SERVICE BULLETIN

Safety Recall Code 0113

MAIN CIRCUIT BREAKER REPLACEMENT

Figure 1. Upper Frame Crossmember (Under Seat)

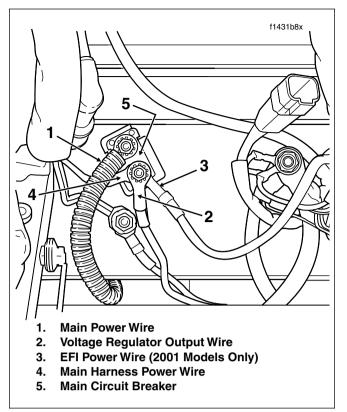
- 5. Locate main circuit breaker on left side of upper frame crossmember. See Figure 1.
- 6. Remove Keps nut from copper post. Remove main power wire ring terminal (with convoluted tubing).
- Remove Keps nut(s) from silver post. Remove voltage regulator output, EFI power (2001 models only) and main harness power wire ring terminals.
- 8. Bend tab on mounting clip outward and remove main circuit breaker.

- 1. Install **new** 50 amp main circuit breaker into mounting clip oriented with the copper post topside. See Figure 1.
- 2. Install main harness power, EFI power (2001 models only) and voltage regulator output wire ring terminals onto silver post. Start Keps nut on post.

Install only upper Keps nuts on silver and copper posts. Discard lower Keps nuts wherever the previous configuration was double nutted.

- 3. Place main power wire ring terminal (with convoluted tubing) onto copper post and start Keps nut.
- 4. Alternately tighten Keps nuts to 20-35 in-Ibs (2.3-4.0 Nm).
